From: [Butler, Steve](#)
To: [Hackenbracht, Jeff](#); [Saeed, Shirwan](#)
Subject: FW: Pages from PID 117607_FRA-161-15.80 Noise Walls_Stage 2_01-22-24_Markups.pdf
Date: Thursday, March 21, 2024 11:27:24 AM
Attachments: [image001.png](#)

Please see response in [Magenta](#) below.

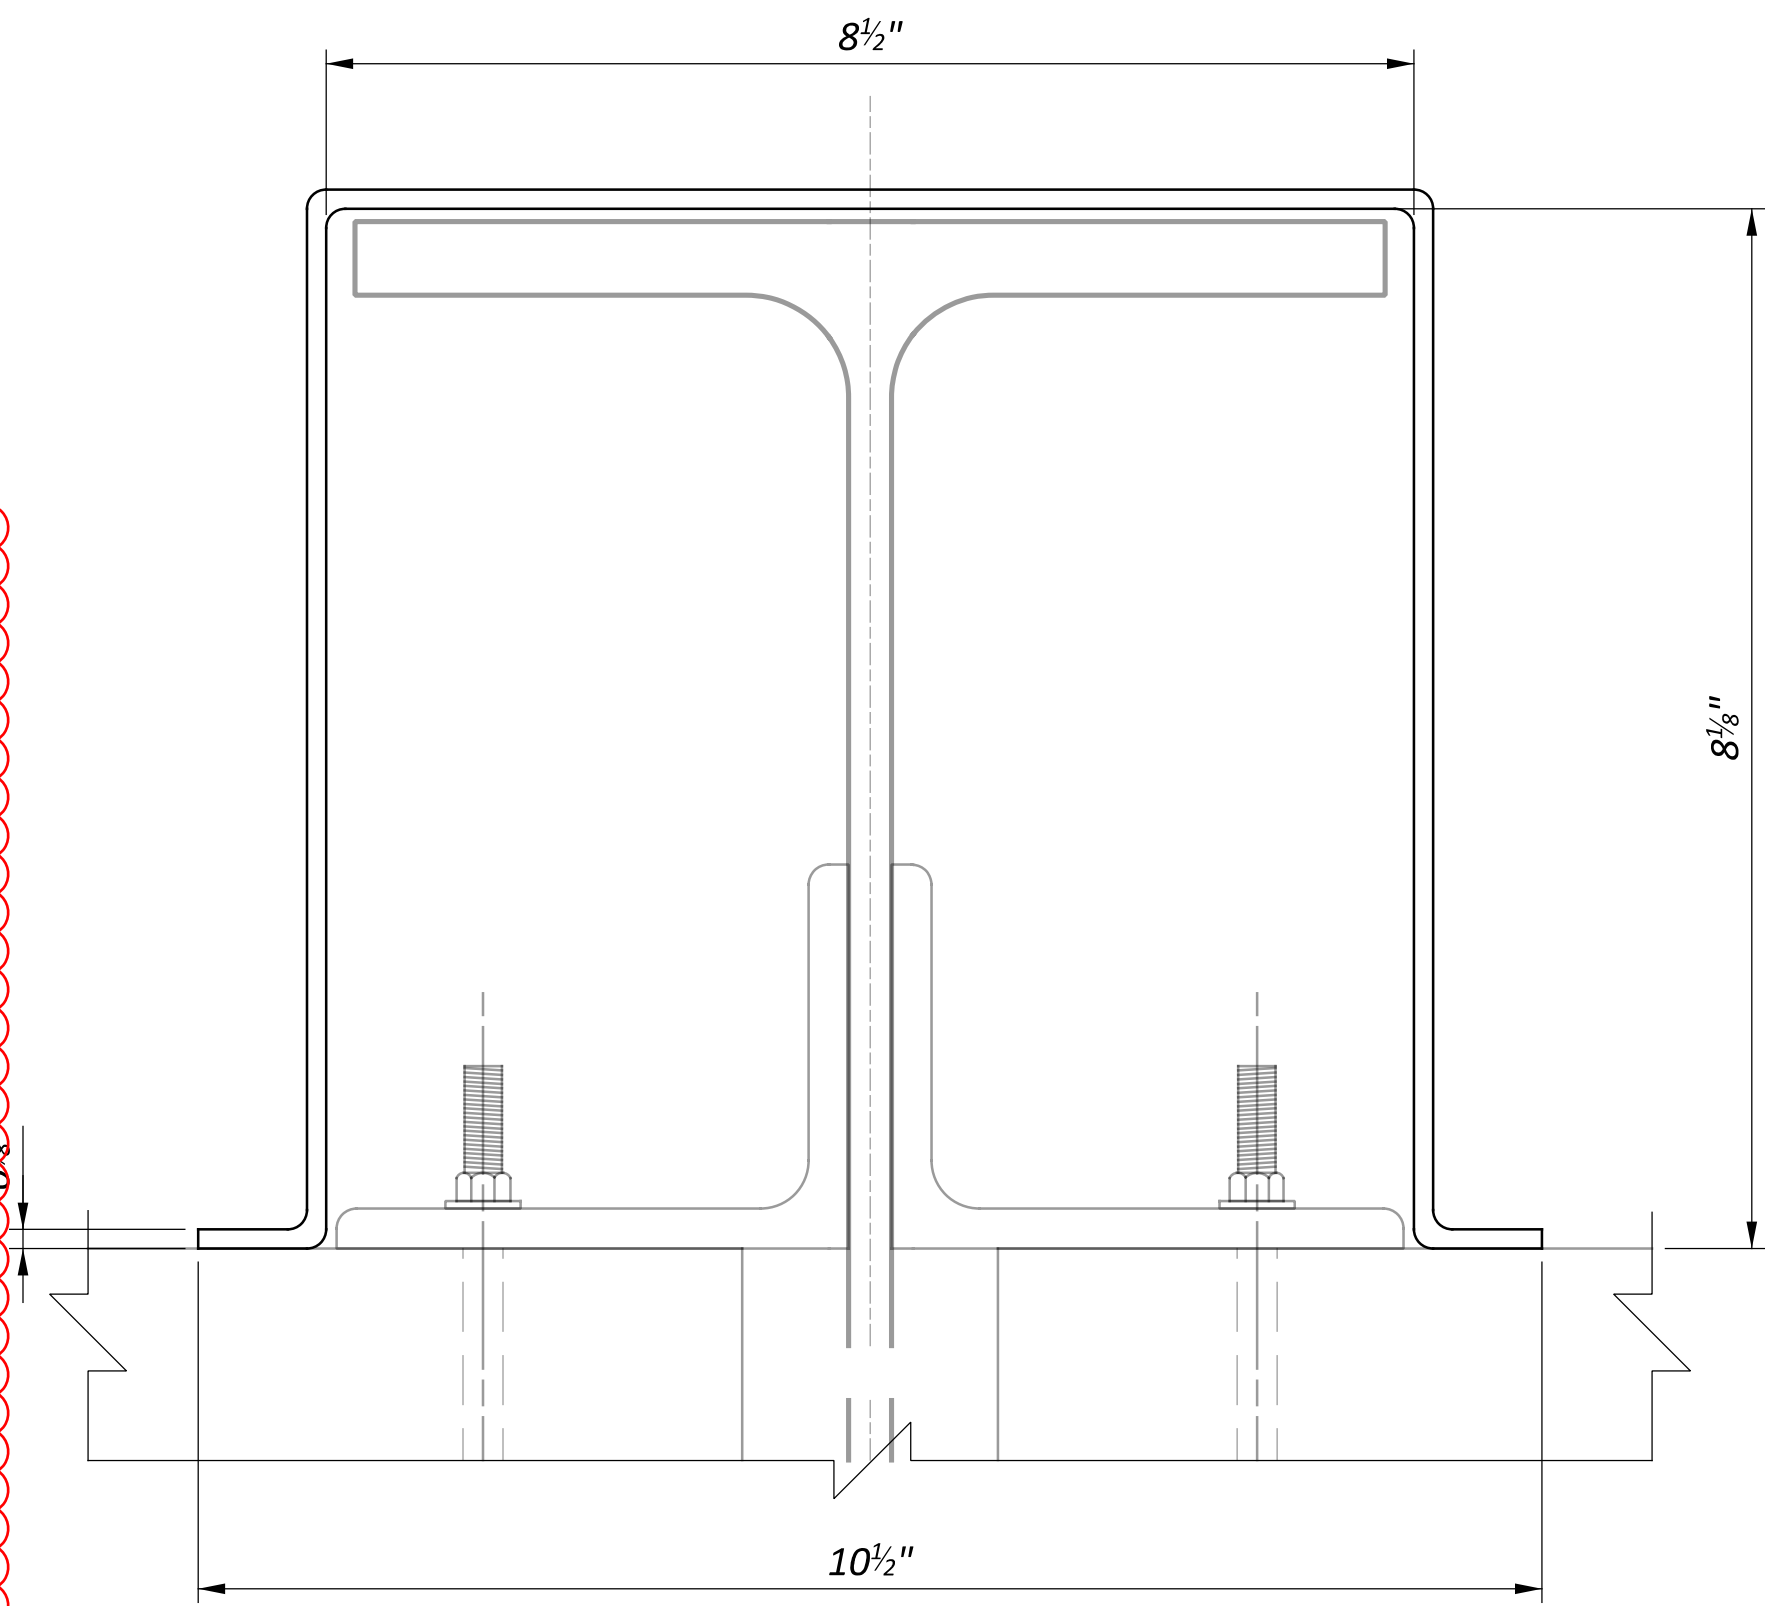
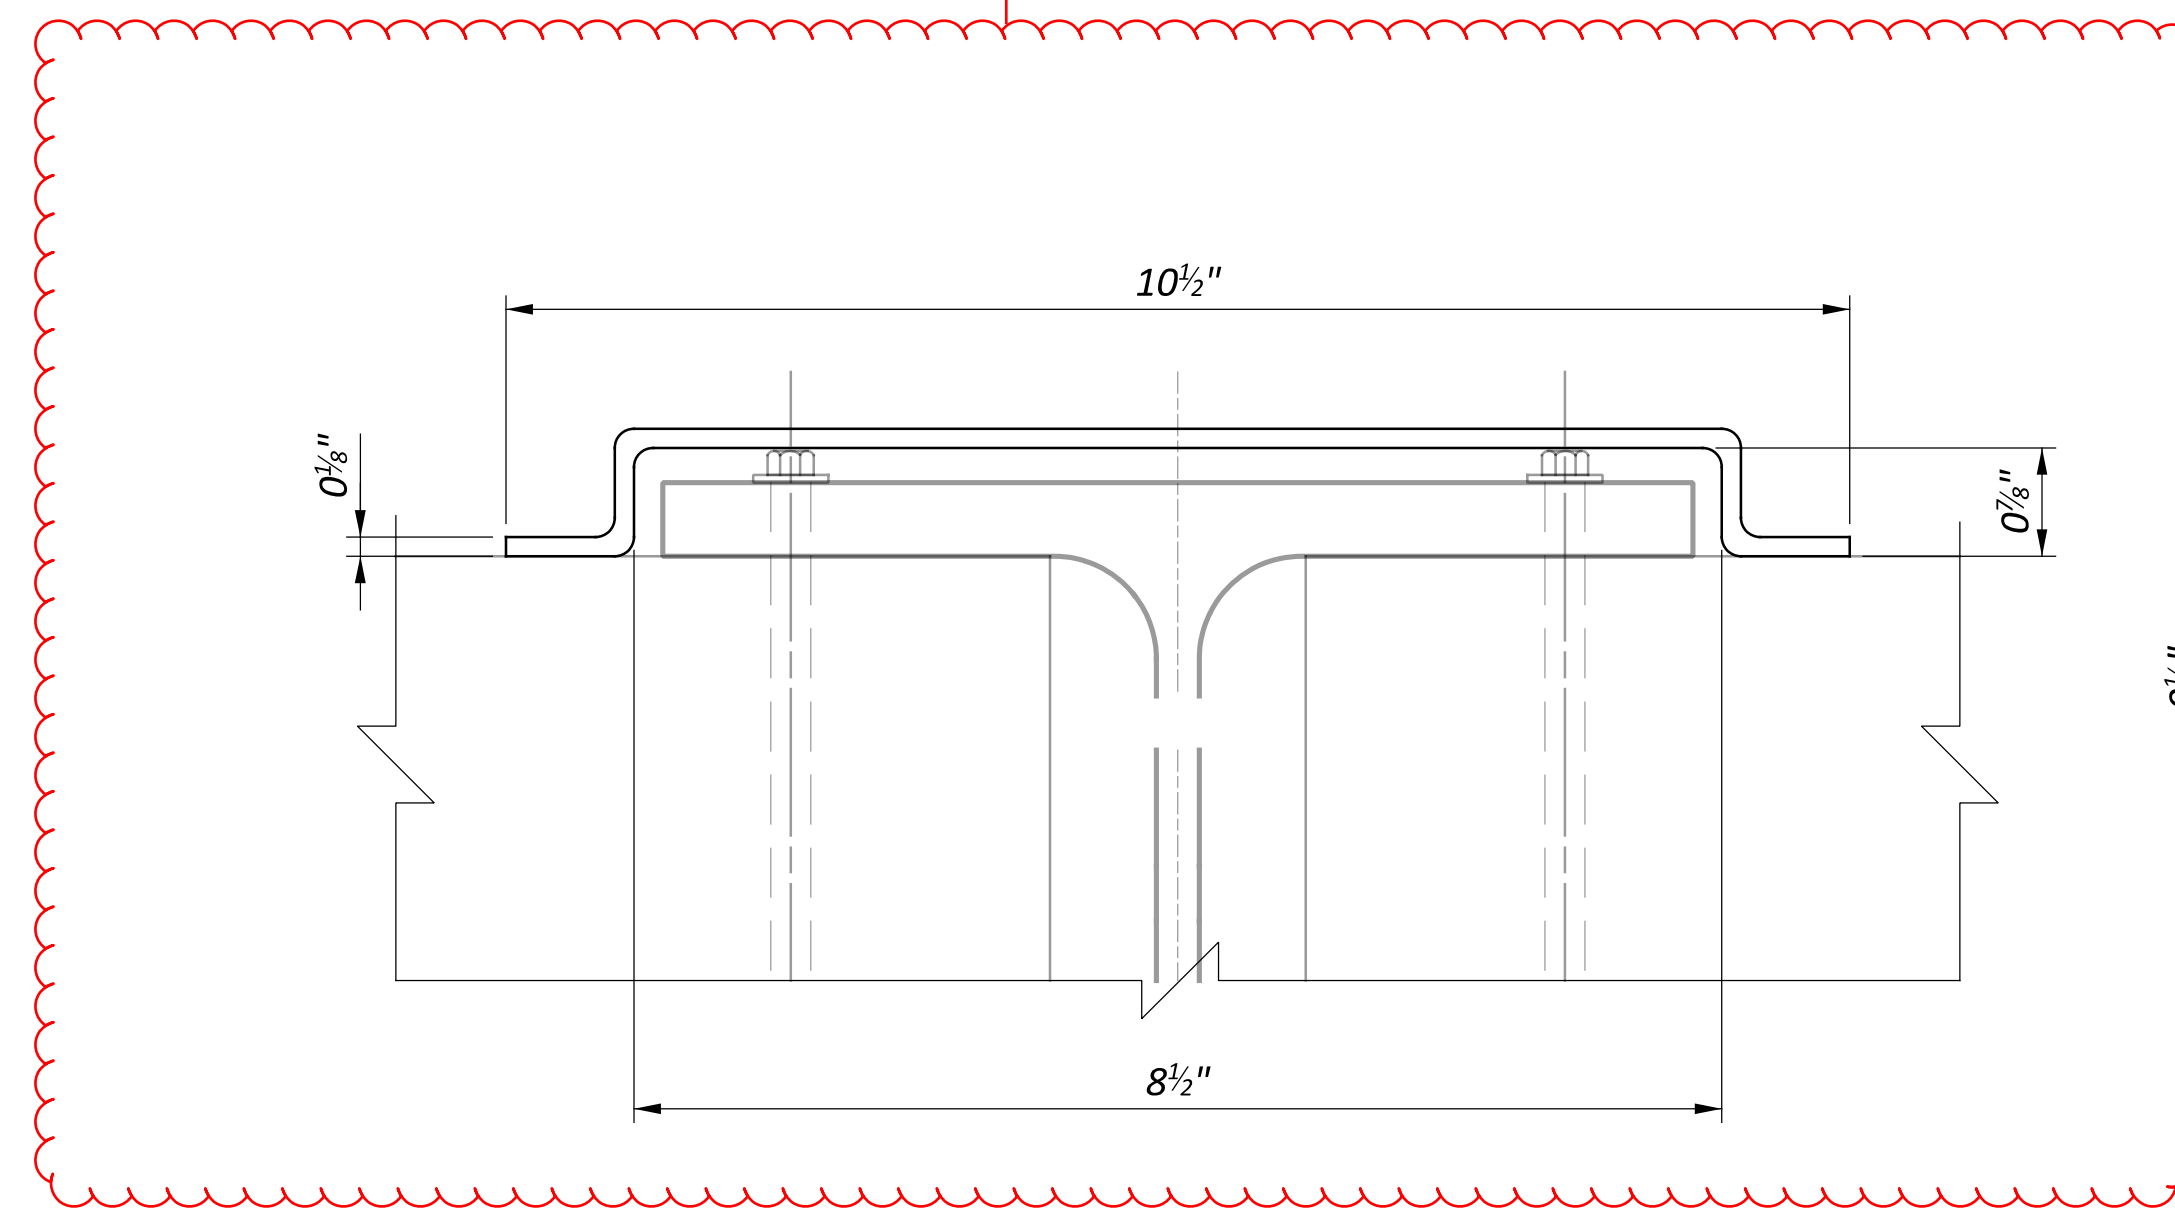
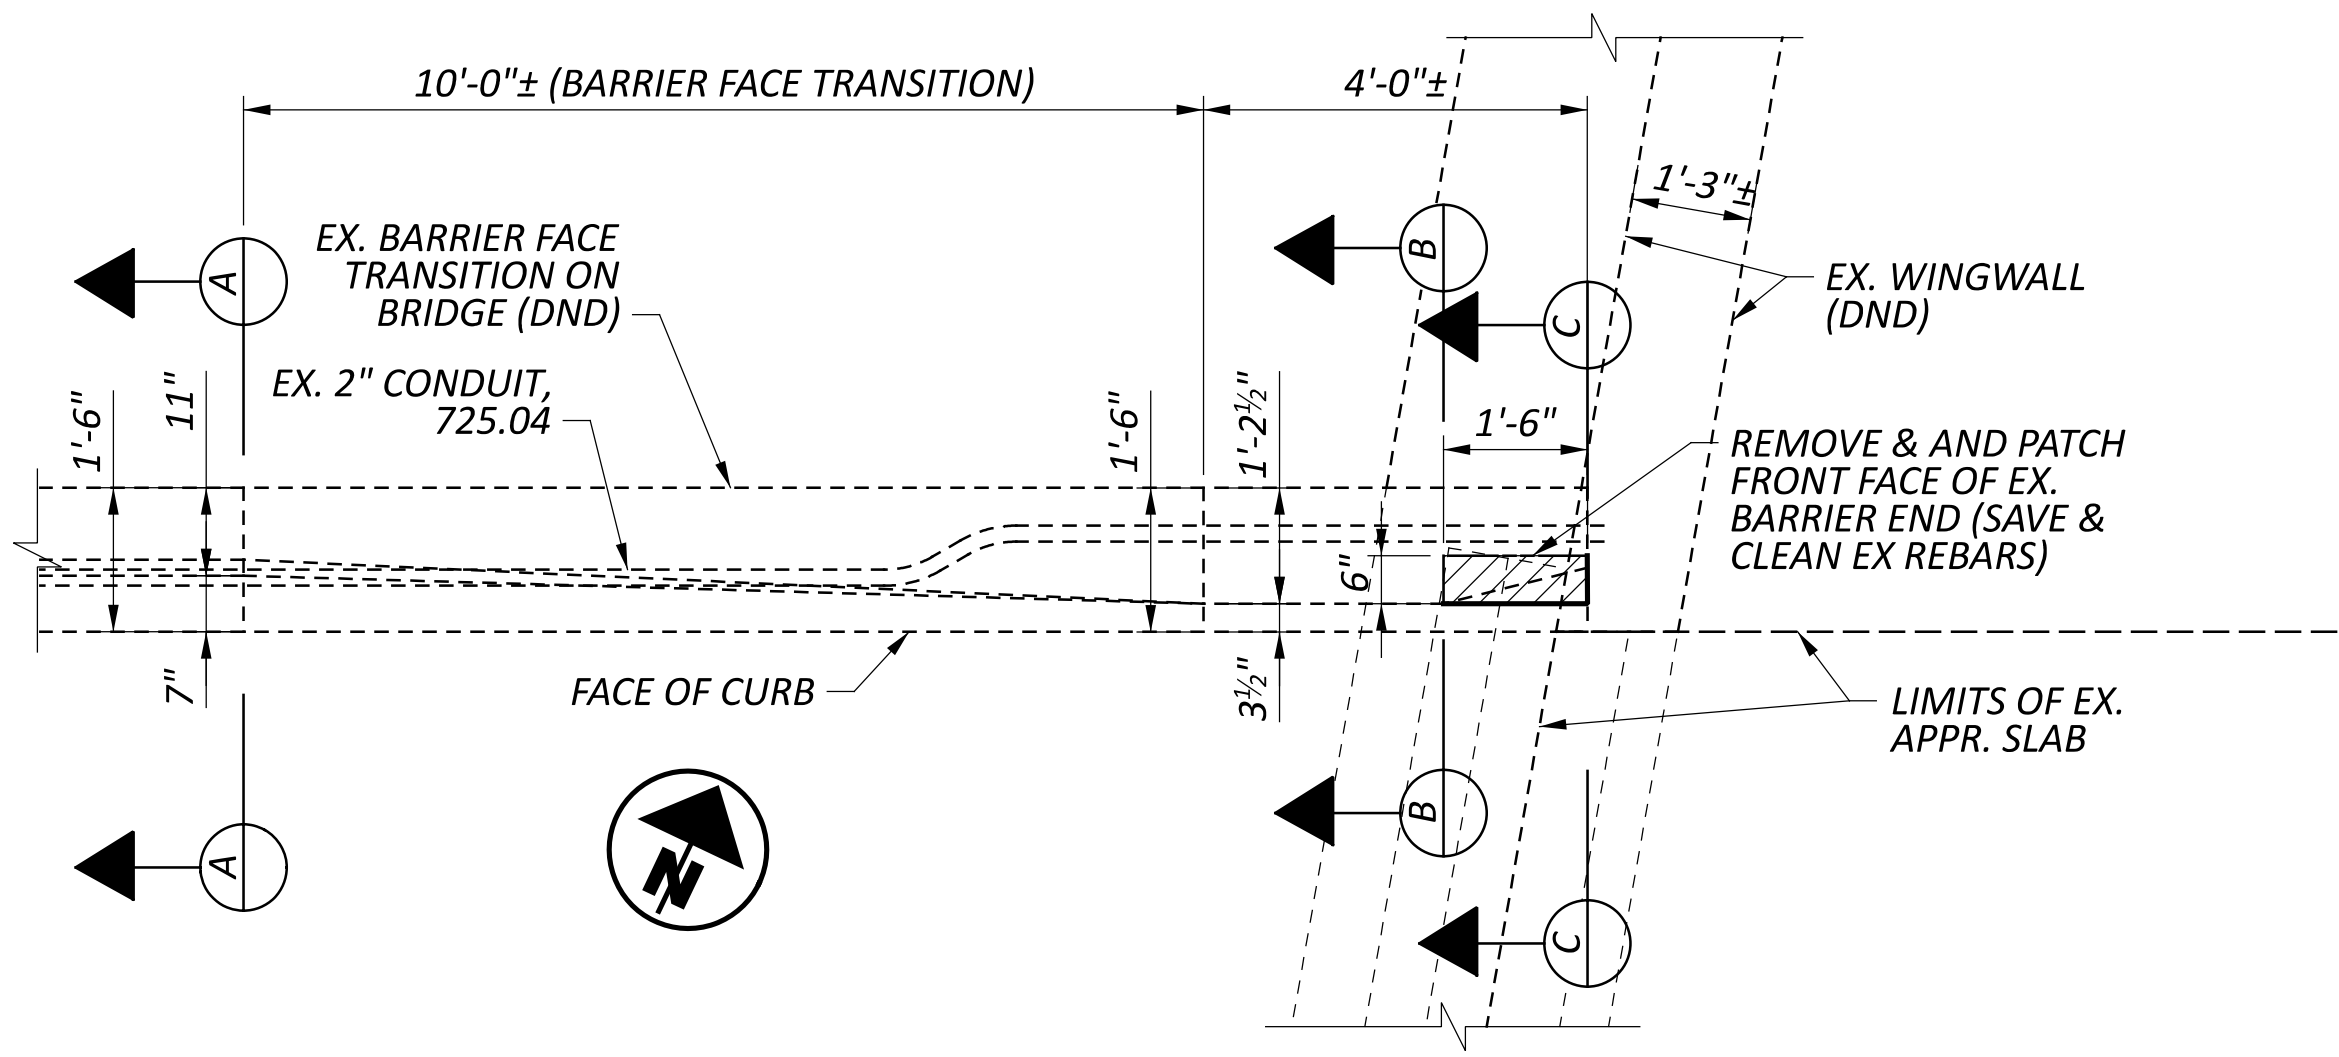
Arcadis Response: See email discussion.
